Product Change Notification: CBOL-08YONY192

CCB 8326 Initial Notice: Qualification of MTAI as a new final test site and scan and pack site for CAP1206-1-AIA-TR, CAP1296-1-AIA-TR, CAP1293-1-AC3-TR, CAP1203-1-AC3-TR, CAP1208-1-A4-TR, CAP1208-2-A4-TR and CAP1298-1-A4-TR catalog part numbers (CPN) available in 8L TDFN (2x3x0.75mm), 10L VDFN (3x3x0.9mm) and 16L VQFN (3x3x0.9mm) packages.

PCN Status: Initial Notification

CCB 8326
Pre and Post Change Summary
PCN #: CBOL-08YONY192

Pre and Post Change – T&R – Cover Tape

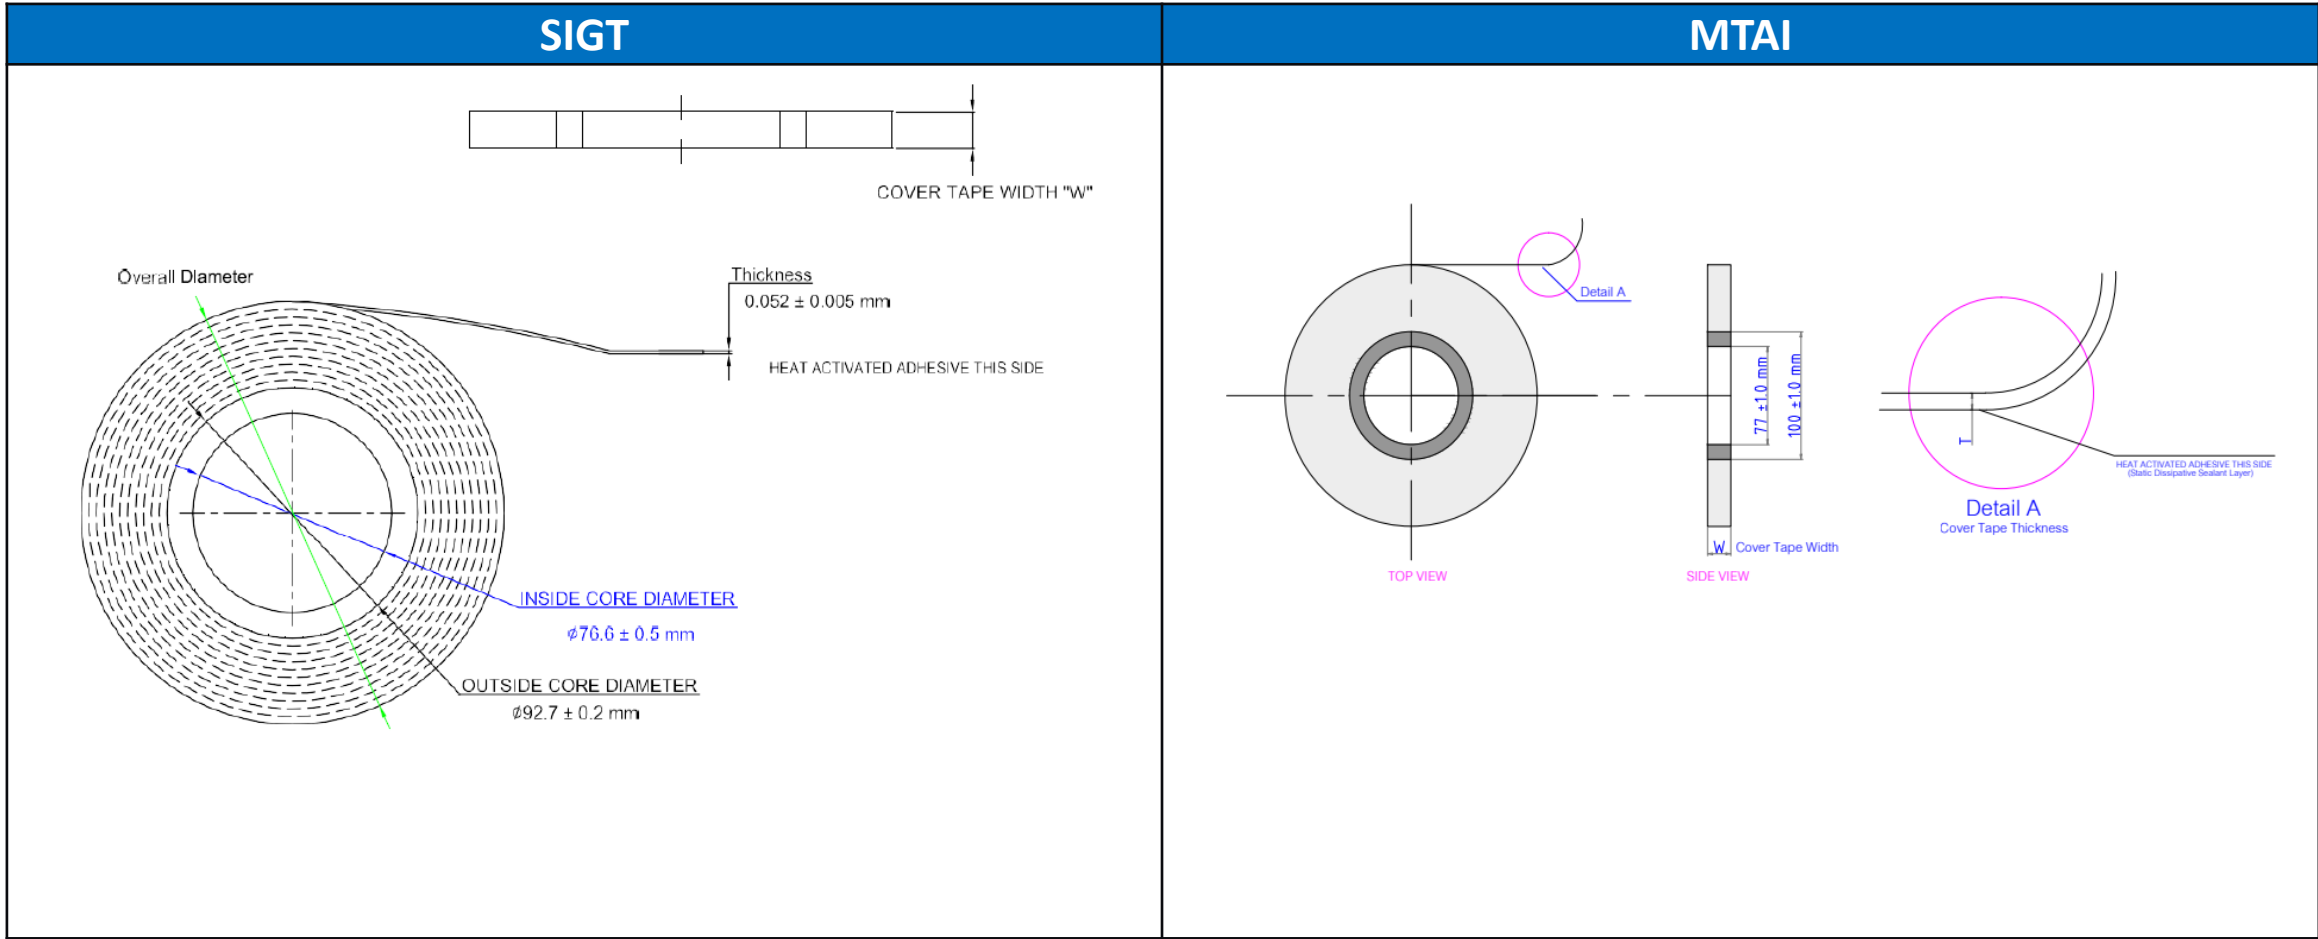
Plant	Width W (mm)	Thickness T (mm)	Color	Sealing Methodology
SIGT	9.30 ± 0.10	0.052 ±0.005	Clear	Heat sealing
MTAI	9.05 +0.05/-0.15	0.050 ±0.010	Clear	Heat sealing

Pre and Post Change – T&R – Plastic Reel

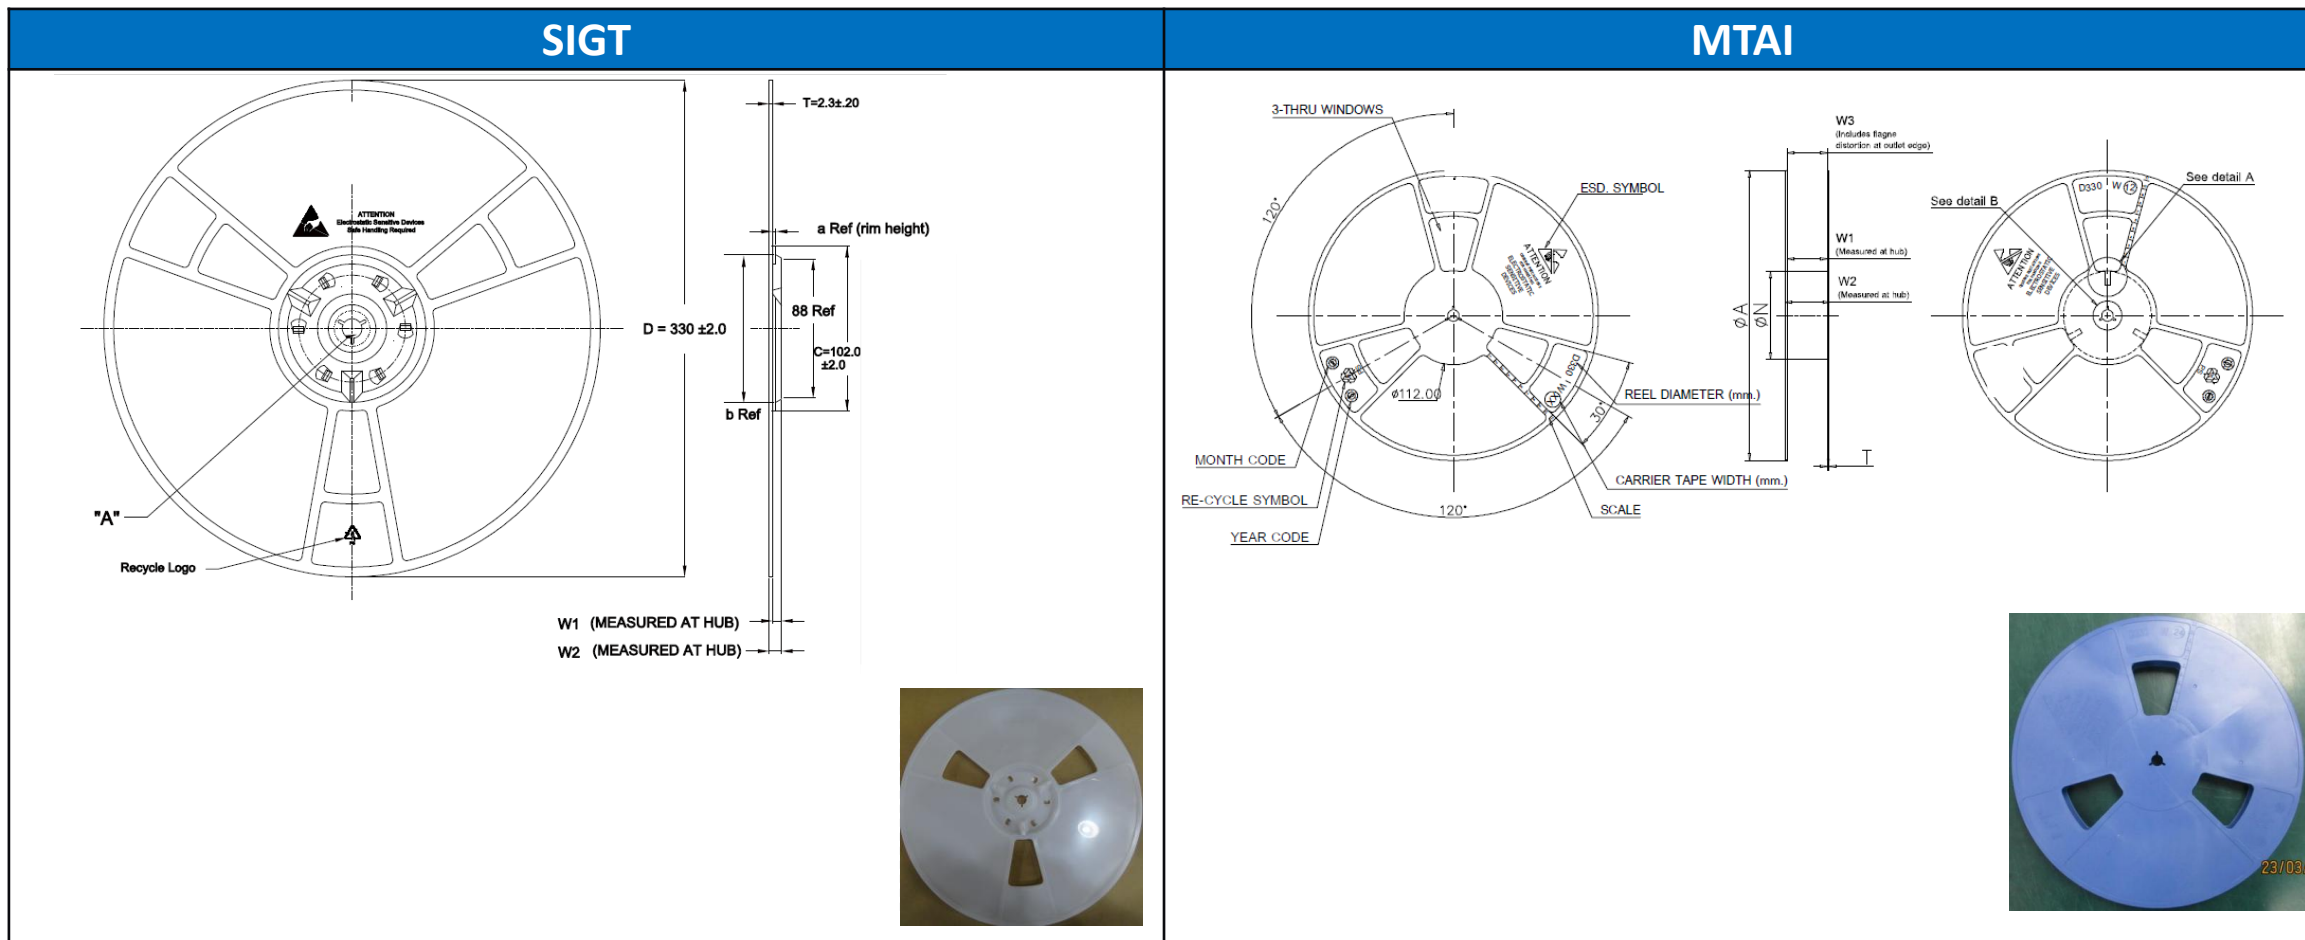
Plant	Reel Diameter (mm)	Reel Hub Size (mm)	Reel Width Max (mm)	Color
SIGT	330 ±2.0	102 ±2.0	18.20	White
MTAI	330 ±2.0	100 ±2.0	18.40	Dark blue

Pre and Post Change – T&R – Bag

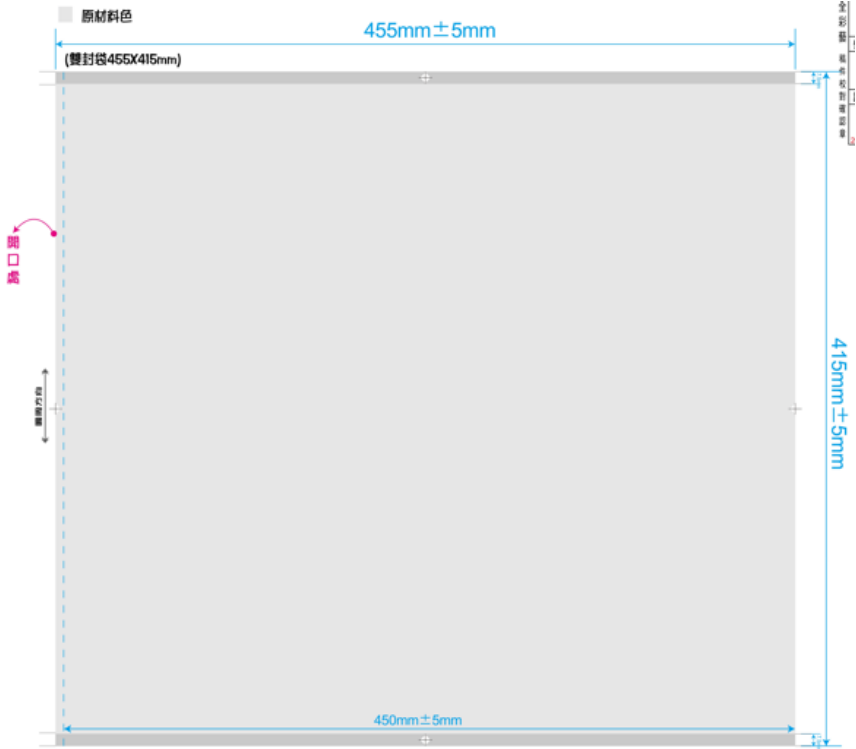
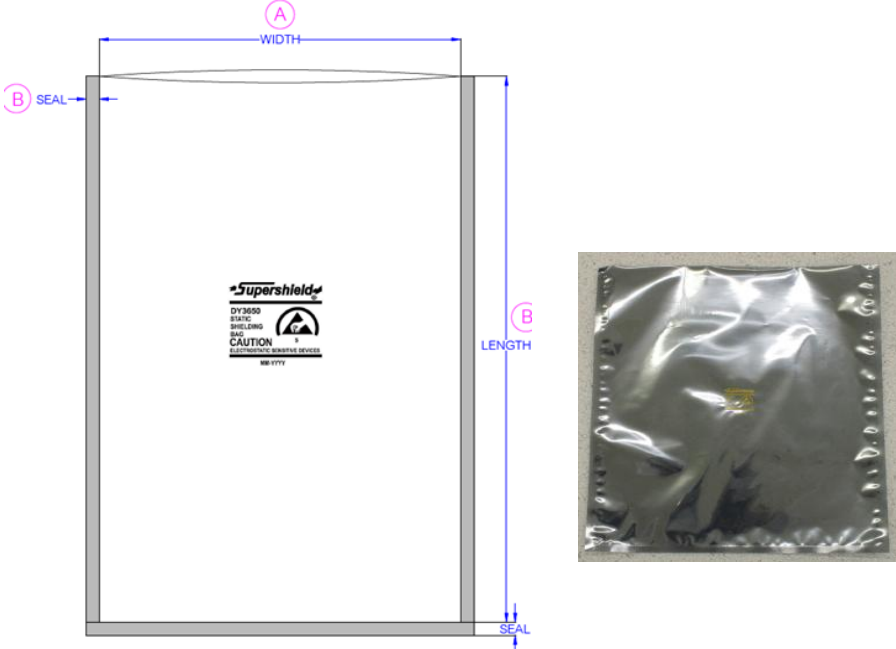
Plant	Moisture Sensitivity Level	Bag type	Length (mm)	Width (mm)	Thickness (mm)
SIGT	MSL-1	Static Shielding Bag	455 +5/-5	415 +5/-5	0.1 +0.01/-0.01
MTAI	MSL-1	Static Shielding Bag	420 +5/-0	370+5/-0	0.0762 +/- 10%

Pre and Post Change – T&R – Packing Method

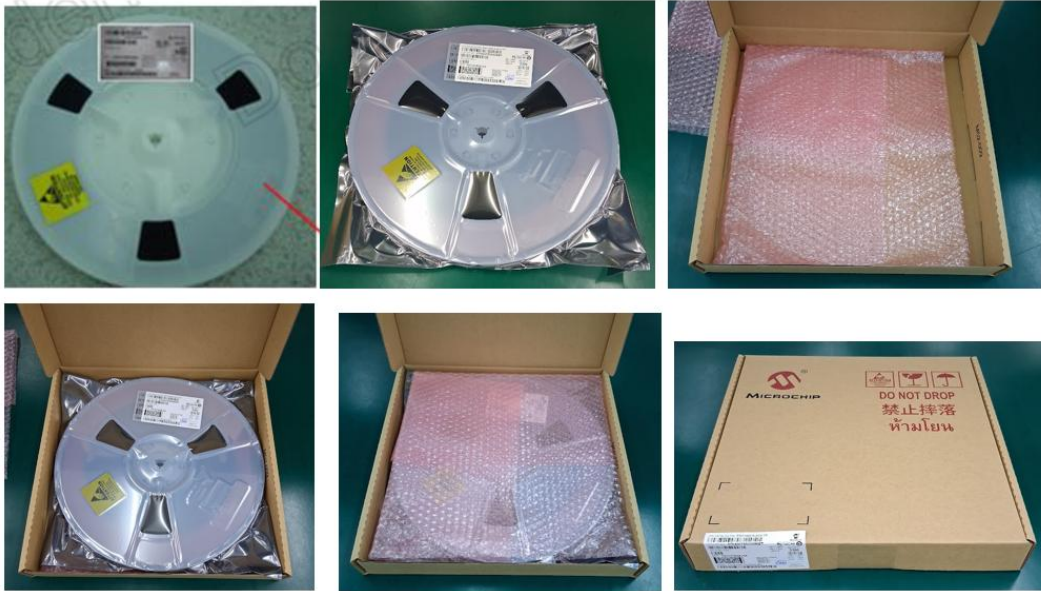
Inner Box
Dimension
W x L x H (cm)

35.6x34x5

MSL-1 (No inner box)

Carton	Dimension W x L x H (cm)	Number of reel per carton
M01-011 (TT)	36.5x38x39.5	15
M01-013 (B2)	35.5x35.5x4	2
M01-014 (B3)	35.5x35.5x6	3
M01-015 (B8)	35.5x35.5x16.5	8
